Number: B106R1013-0

## SERVICE BULLETIN

Subject: Track Spacers Ride: ZIPPER

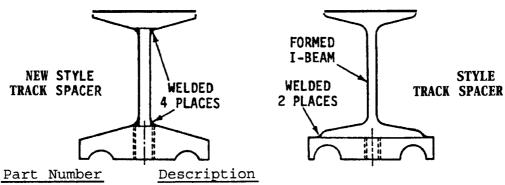
As a safety precaution, CHANCE RIDES, INC. requires that the owners of all ZIPPER amusement rides replace the track spacers between the straight and curved track sections at each end of the boom. A heavy, fabricated spacer is now available to replace the formed I-beam spacer previously used (See illustration).

Remove all old style track spacers from rides, and replace with the new style 1-1/2, 2, 2-1/2, and 3-inch spacers. Be sure to use the correct size attach plate for each track spacer. Refer to the instructions on Service Bulletin B106R1008-0 and the procedure in the operation manual.

AFTER JANUARY 1, 1988, DO NOT OPERATE THE RIDE WITH THE OLD STYLE TRACK SPACERS INSTALLED.
